**Brooklyn Inland Wetlands Commission  
Regular Meeting Agenda  
Tuesday, June 9, 2020  
Clifford B. Green Memorial Center  
69 South Main Street  
6:00 p.m.**

As you requested, I have reviewed the developer's consulting engineer's plans for the above captioned project. A copy of my comments are enclosed pertaining to my review of the plans, consisting of five sheets, entitled "Proposed Parking Expansion, 'Vachon Chevrolet', Providence Road (Route 6), Brooklyn, Connecticut, Prepared for Vachon Brooklyn, LLC.," which were created by Killingly Engineering Associates, dated January 2020 with revision date of March 10, 2020.

In response to NECCOG review comment on the aforementioned project, we offer the following:

<b>Killingly Engineering Associates</b> Civil Engineering & Surveying 114 Westcott Road P.O. Box 421 Killingly, Connecticut 06241 (860) 779-7299 www.killinglyengineering.com	
DATE: 1/07/2020	DRAWN: AMR
SCALE: 1" = 40'	DESIGN: NET
SHEET: 4 OF 5	CHK BY: ---
DWG. No: CLIENT FILE	JOB No: 19129

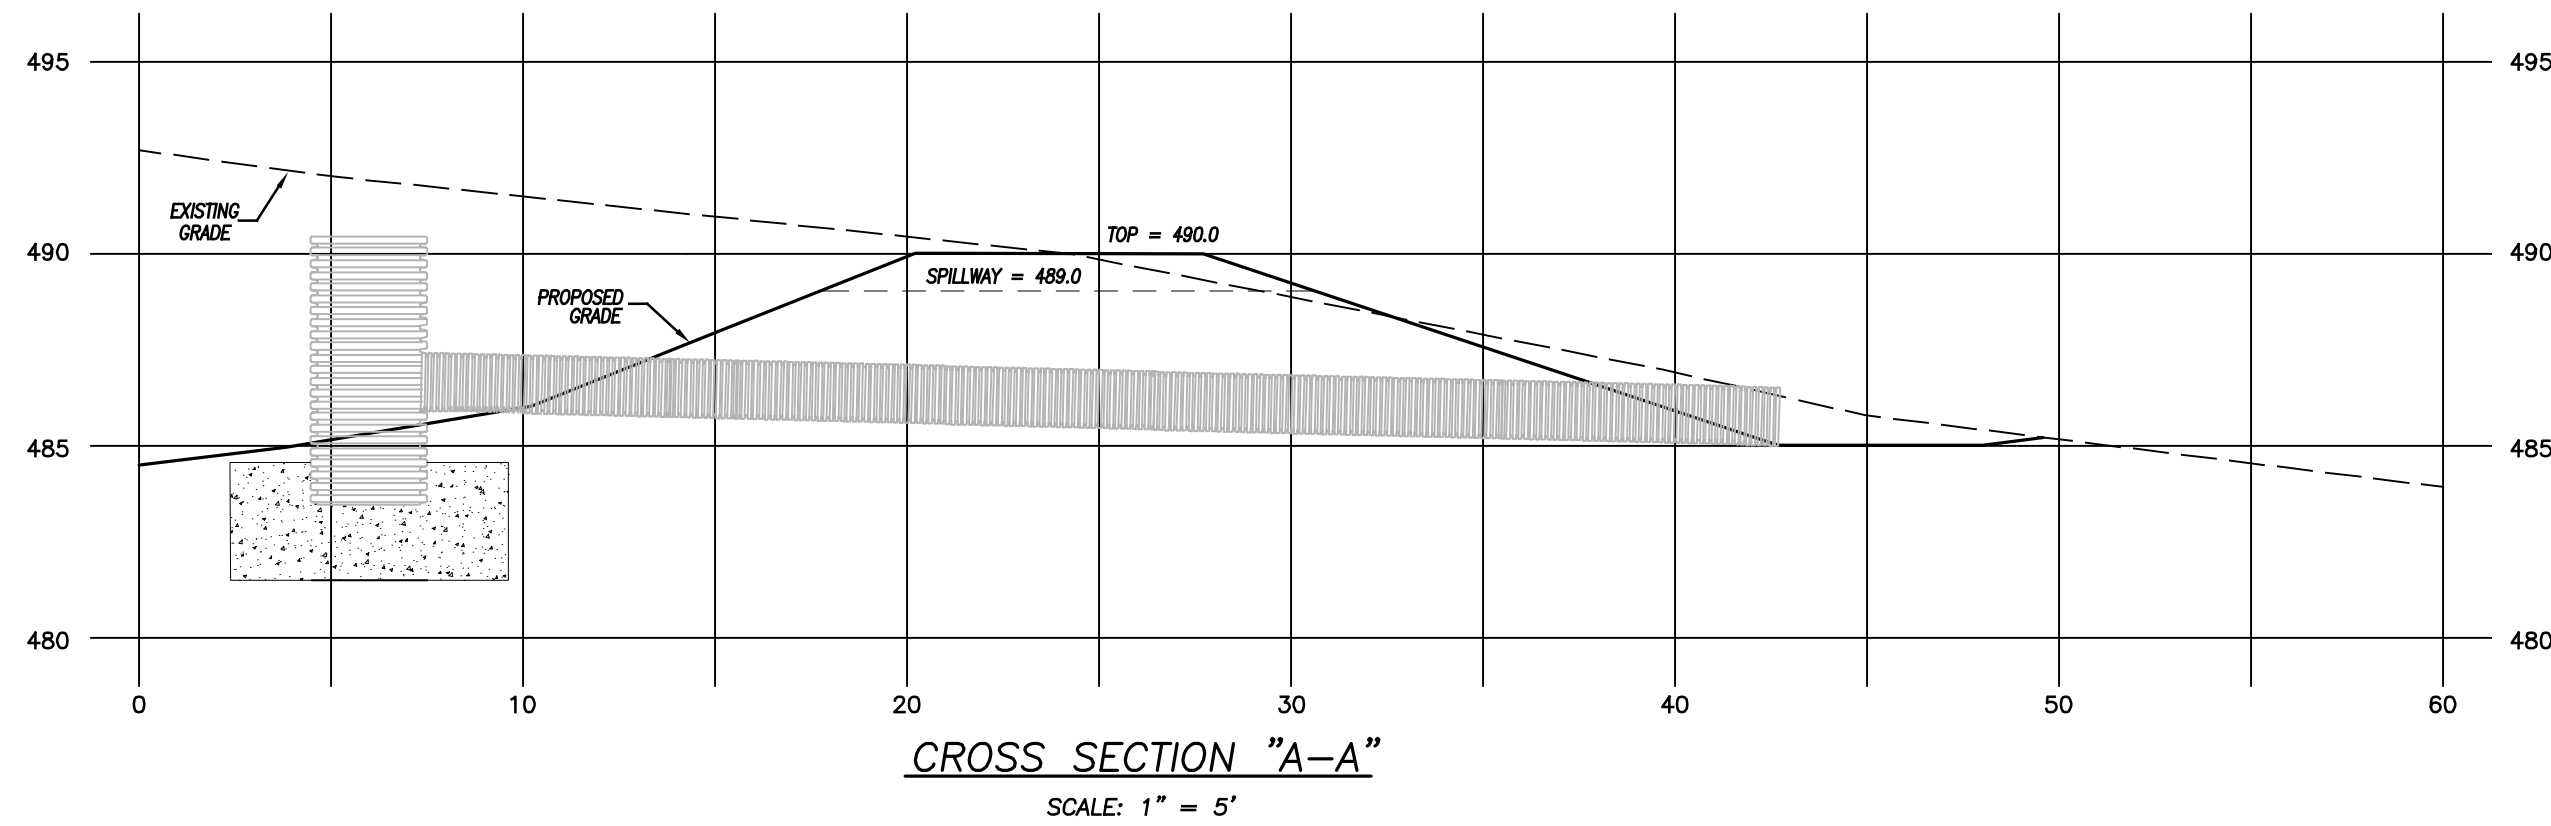
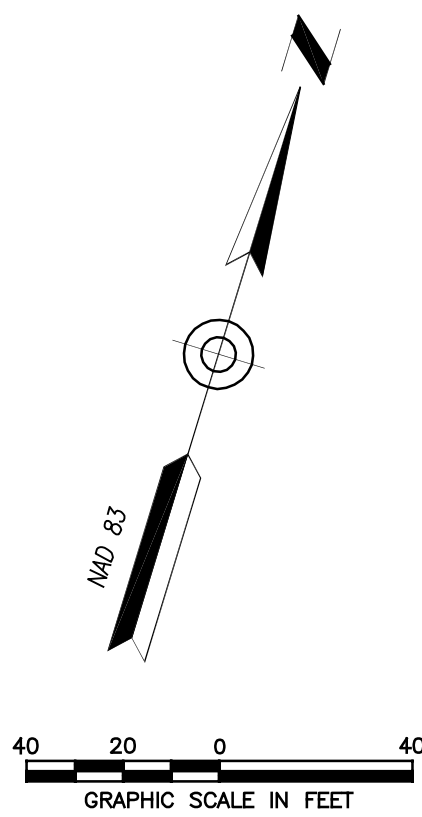
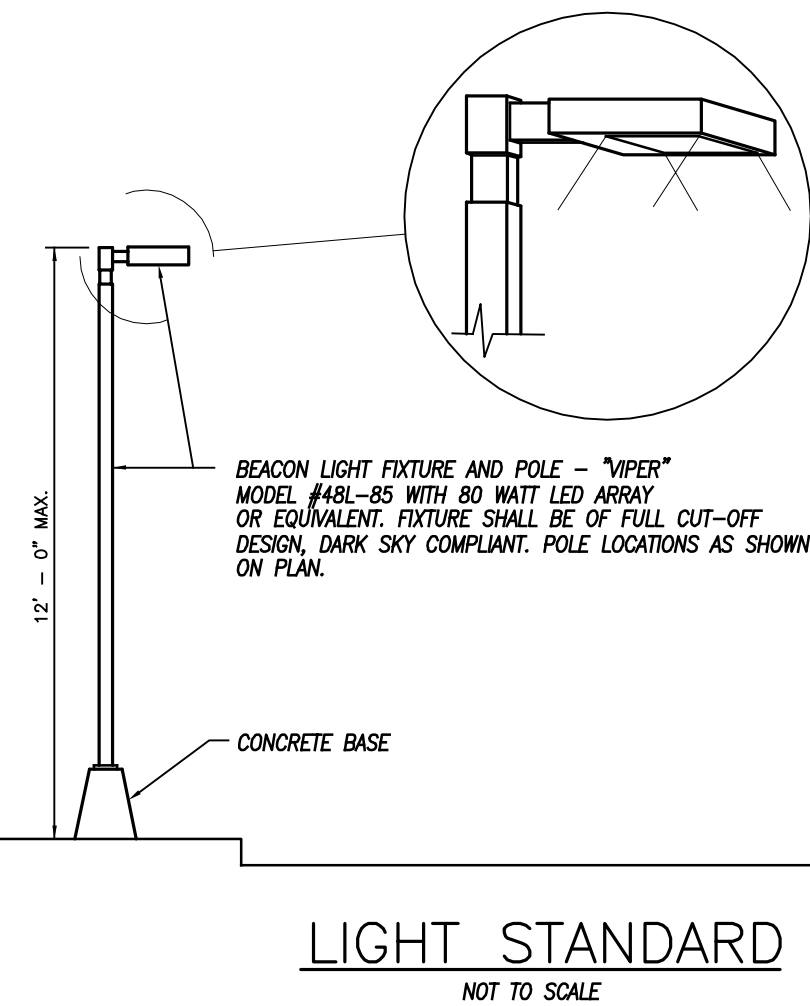
3. How will snow removal be handled in this area so as not to impact the adjacent wetlands (salt or other ice removal chemicals) and proposed landscaping?
4. It is unclear on how the "island" in the middle of the proposed parking area is going to be constructed, i.e., raised island with landscaping; raised island paved with no landscaping; flush with whatever in between; etc.? Can this area be used as a rain garden to mitigate some of the runoff from the pavement?
5. Is there any consideration to provide some form of "tall" landscaping in the center island, considering how much impervious pavement is being proposed?
6. As an aid to construction, it would be helpful to include a cross-section profile from the detention basin outlet structure to just beyond the level spreader.

1. Slopes in the detention basin have been modified so that they do not exceed 2:1 (center berm only). We have also noted that jute netting shall be installed to stabilize the basin after topsoil and seed have been applied. The center berm is designed to extend detention time in the basin and we do not anticipate erosive conditions once stabilized.

3. Snow will be stockpiled at the top of the slope adjacent to the proposed stormwater basin. Sheet 5 of the plans specify that no salt or chemical applications for snow removal shall be used.

4. The island in the center of the site will be depressed. We will incorporate rain garden plantings into the island to promote stormwater treatment and infiltration.
5. As the center island will be utilized in the capacity of a rain garden, we do feel that taller vegetation would be appropriate.
6. A cross section of the basin outlet has been added to the plans as requested.

DATE: 1/07/2020	DRAWN: AMR
SCALE: NOT TO SCALE	DESIGN: NET
SHEET: 5 OF 5	CHK BY: ---
DWG. NO: CLIENT FILE	JOB NO: 19129

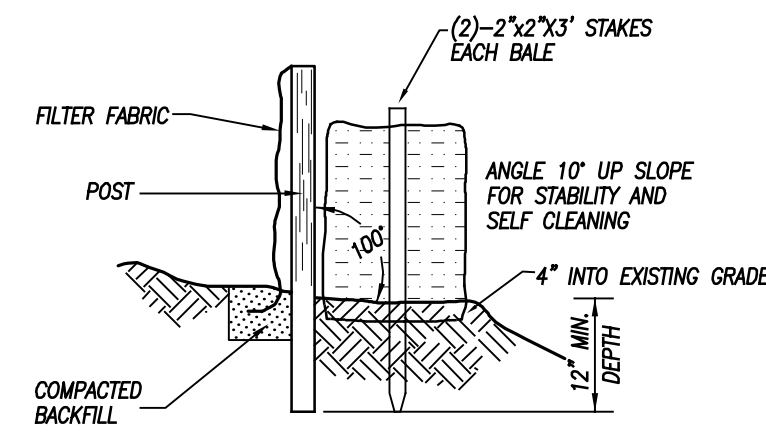
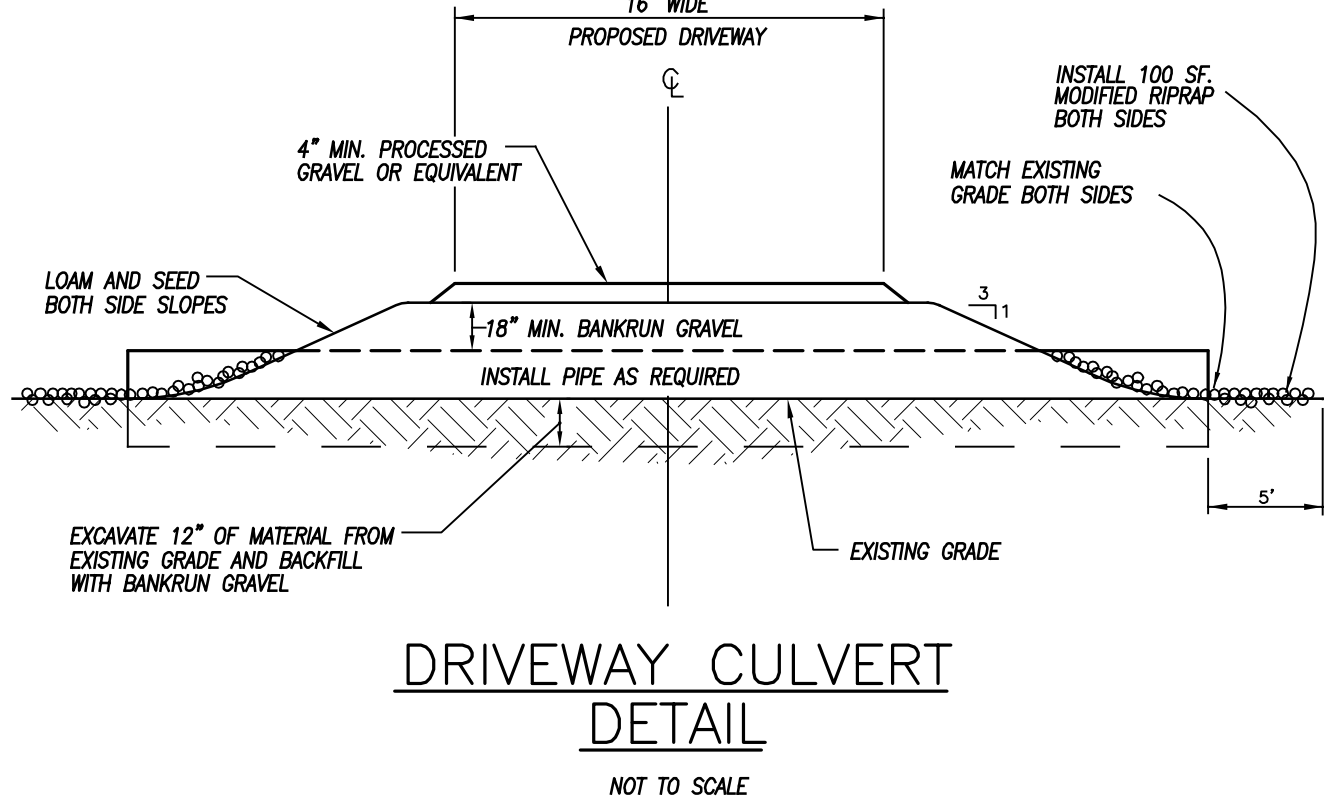
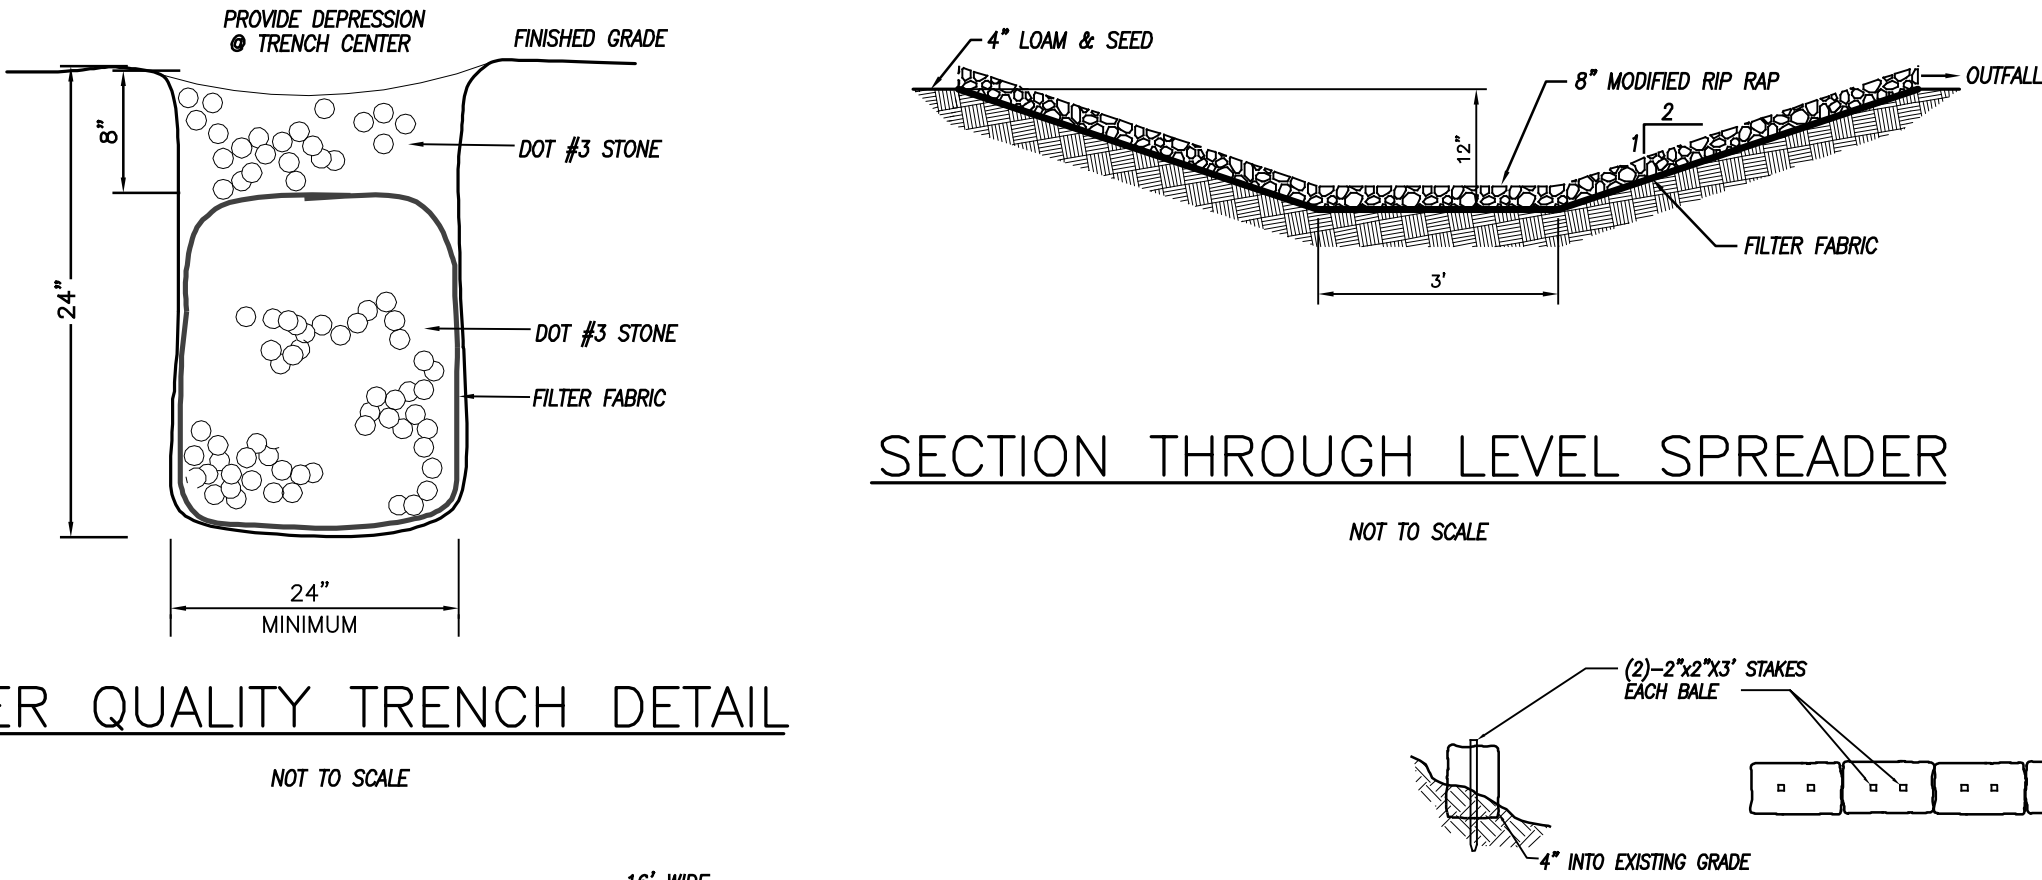
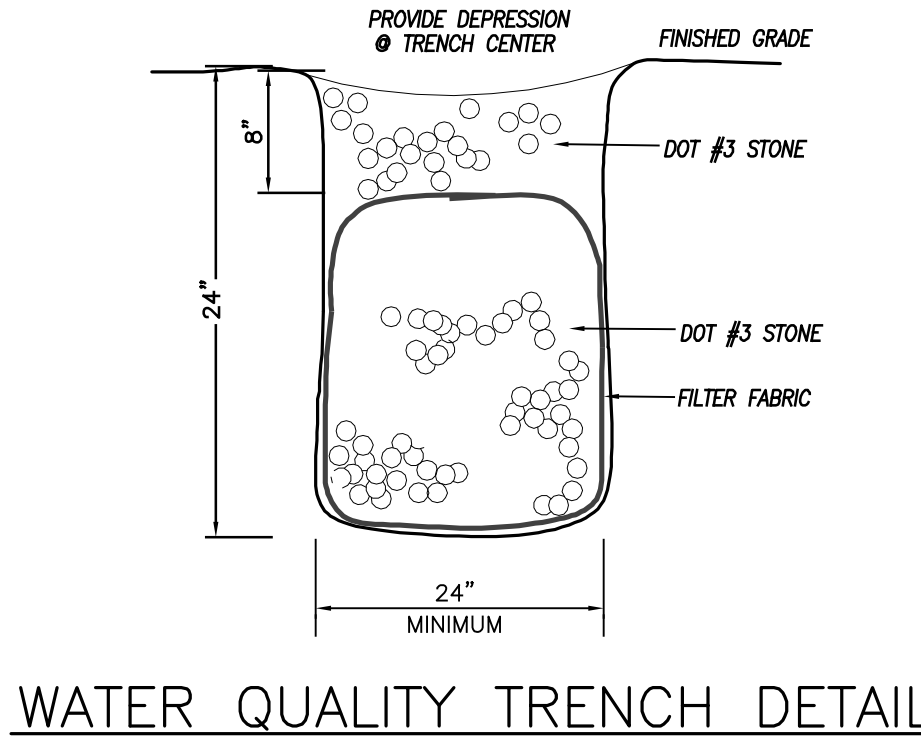
1. In the "Stormwater Basin Outlet Detail," a smooth outer wall PVC pipe may be less susceptible to upheaval or degradation (breakage) by icing conditions than a corrugated type of pipe. It is recommended that this be evaluated by the designer. Furthermore, over time, ultraviolet rays in sunlight degrades unprotected plastic pipe, which causes it to lose structural integrity and stability. Considering this, concrete may be a better choice.

2. In the "Stone Berm" detail, what specific type of filter fabric should be used to minimize sediment transport and at the same time allow the efficient transmission of water toward the outlet structure? This should be specified in the detail. Also, what are the conditions as to when the berm should be replaced to function as designed due to sediment build up?

4. In the "Chain Link Fence Detail" the gauge of the fence fabric and size of the selvage should be specified and also what type of material it is manufactured from (galvanized steel, PVC coated steel, etc.). The same goes for the posts and hardware, too, and depth of bury/concrete anchorage for the posts.

5. In the "Stone Berm" detail, will CONNDOT crushed stone M.01.01 #3 remain stable at a 2:1 angle of repose?
6. In the "Slope Stabilization Detail" it is recommended that the slope be 3:1 or flatter, **NOT** 2:1 or steeper, as shown.

2. For the stone berm, specifications for the filter fabric have been called out and conditions for maintenance are defined.
3. The silt fence detail has been modified to read “super silt fence” as requested.

4. The detail for the fence installation has been modified as requested. In addition, neighbors who attended the public hearing for wetlands requested an 8’ fence in lieu of a 6’ fence which has been accommodated.

6. We have modified the slope stabilization detail to call for application on slopes 2:1 or flatter per 5-4-10 of the 2002 Guidelines.
7. Bituminous curb installation detail has been modified accordingly as requested.

SILT FENCE - BACKED WITH HAYBALES

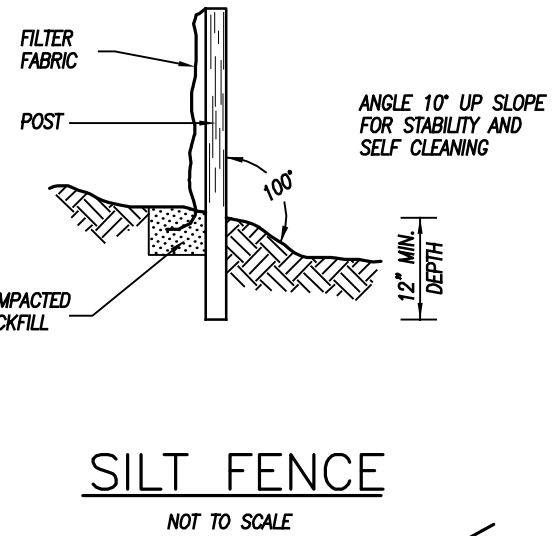
3. It is recommended that the "Silt Fence – Backed with Haybales" detail title be modified to read "Super Silt Fence (Silt Fence Backed with Haybales or Wood Chip Berms)."

BITUMINOUS CONCRETE LIP CURBING

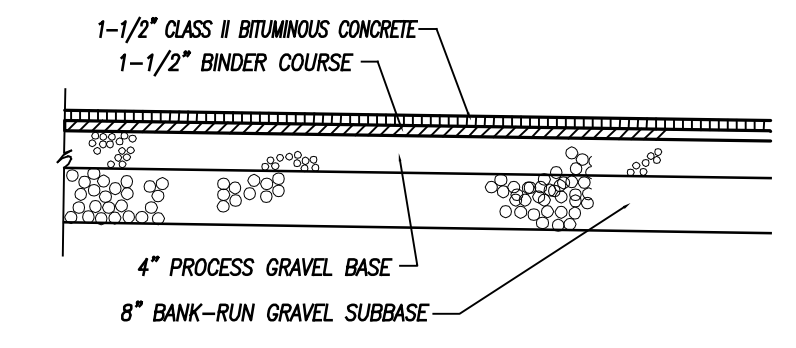
7. In the "Bituminous Lip Curb" detail it is recommended that the curb be formed on the binder course (locked in) for better stability/longevity, which should provide more resistance to deformation by snowplowing operations or other vehicle impacts.
